Replacing the RLC In-limit Switch Bracket

How to replace PN 04861-1 Sheet metal limit switch bracket and PN85446-1 collar with PN 04862 Cast black limit switch bracket and split collar.

AFTER REPLACEMENT

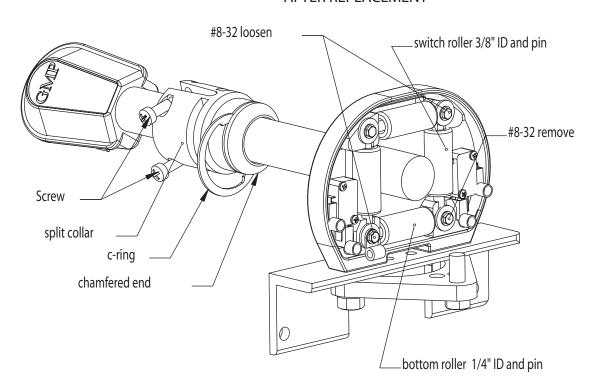
- 9. Remove one #8-32 screw and loosen the two adjacent #8-32 screws.
- 10. Remove switch and bottom rollers and pins Note side roller has 3/8 ID
- 11. Put cord end thru opening as shown.
- 12. Reinstall rollers and #8-32 screws.
- 13 mount bracket to pipe clamp and fascia.

To attach split collar to cable with chamfered side toward the rollers

- 14. Remove screws, nut and c-ring from collar and place two halves on cable.
- 15. Reinstall screws, nuts and c-ring.
